**ADDENDUM NO. 1**

**Cactus Avenue and Other Roads**

**WORK ORDER: H15045**

**AREA: Bloomington**

SPEC.  
DWG.  
135c

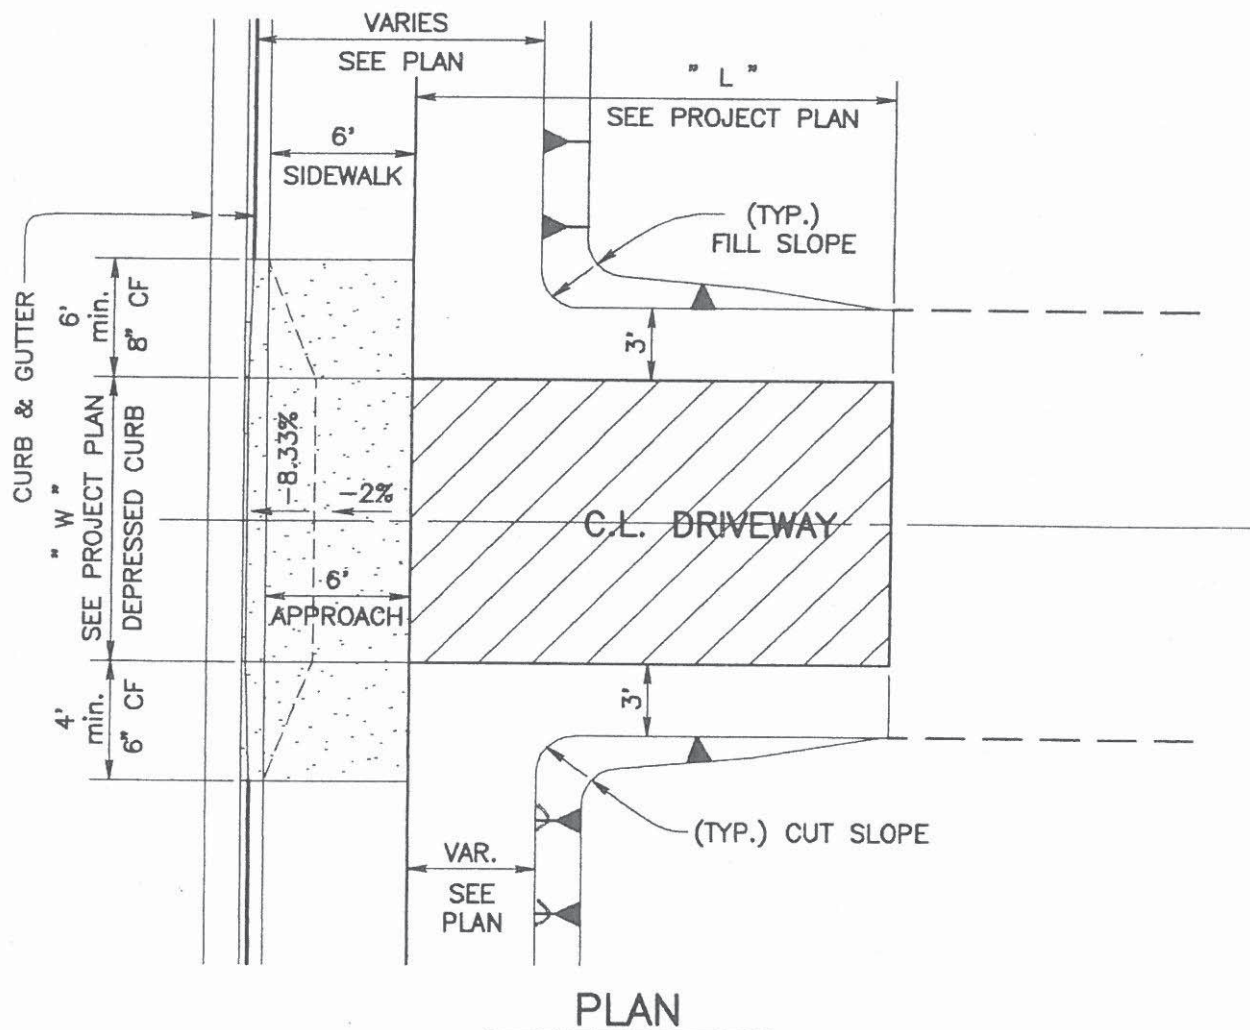
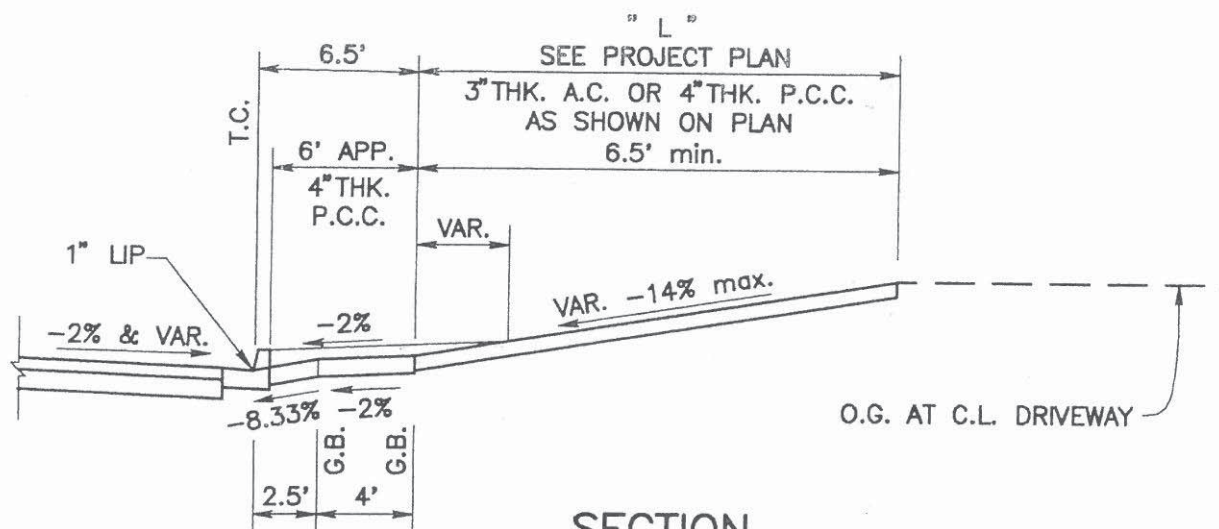
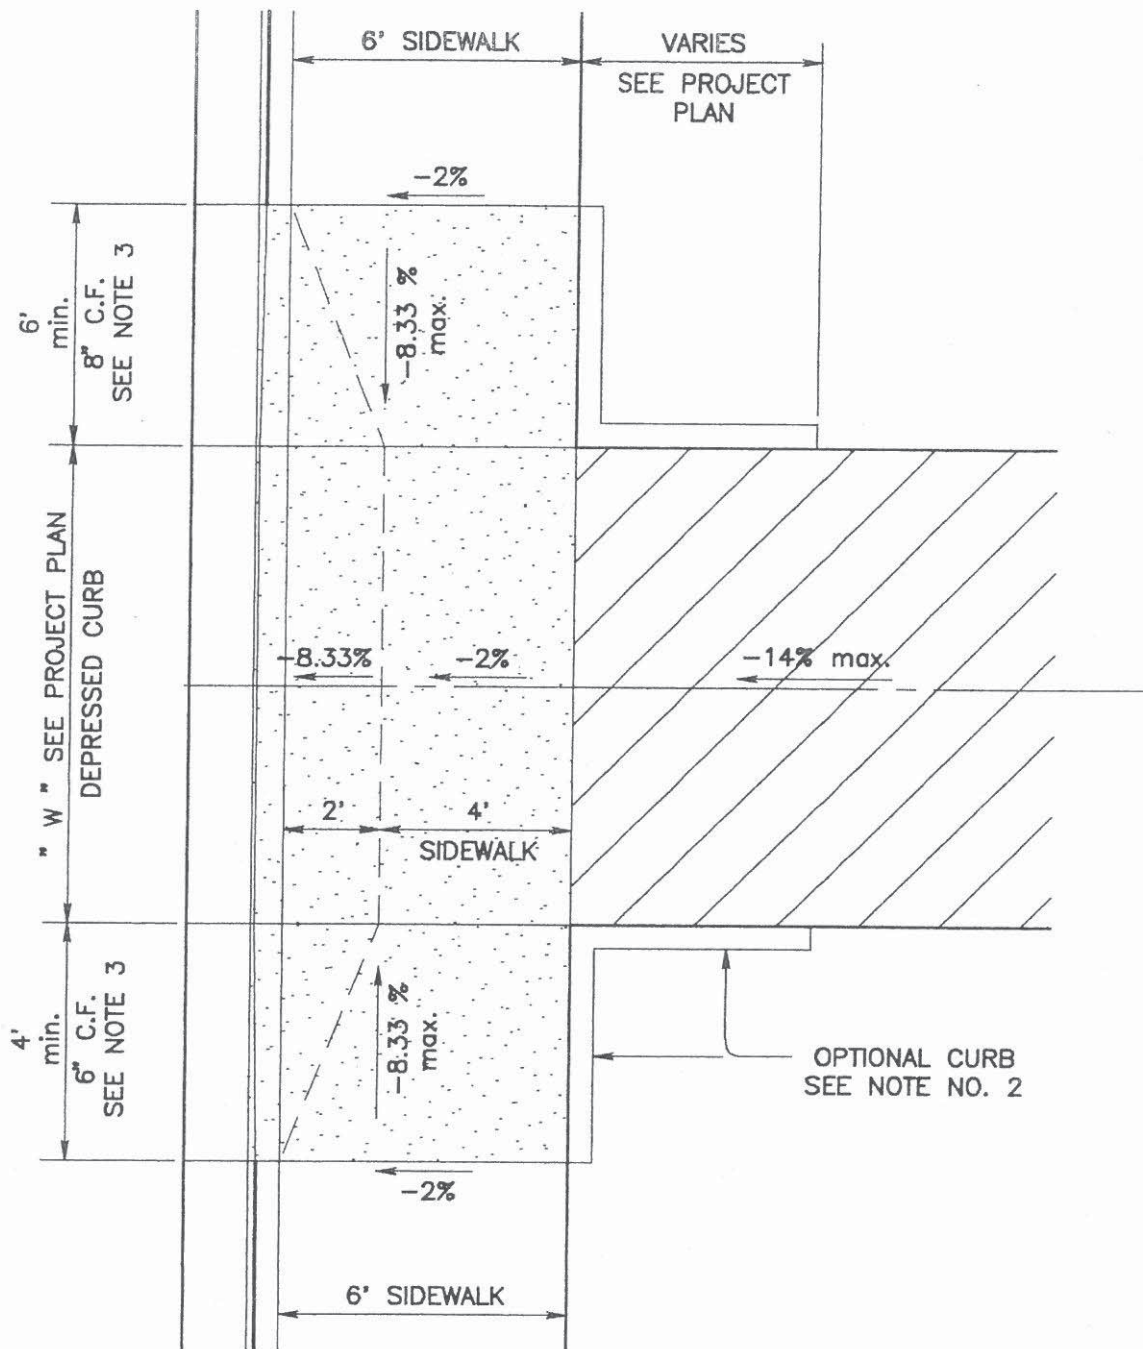
Driveways shall conform to the provision in Section 73, "Concrete Curbs and Sidewalks," of the Standard Specifications and these Special Provisions. The contractor shall maintain all the accesses to the home owner throughout the construction of the driveway approach. The driveway shall be construction in accordance to San Bernardino County Standard 135C.

5. Based on the current plan, there is no driveway approach replacement and the quantity of bid item #24 is way more than what is needed. Please verify the quantity. 11376 Cactus Ave shall have the driveway removed and reconstructed per these special provisions and also the attached driveway standard from San Bernardino County - 135C
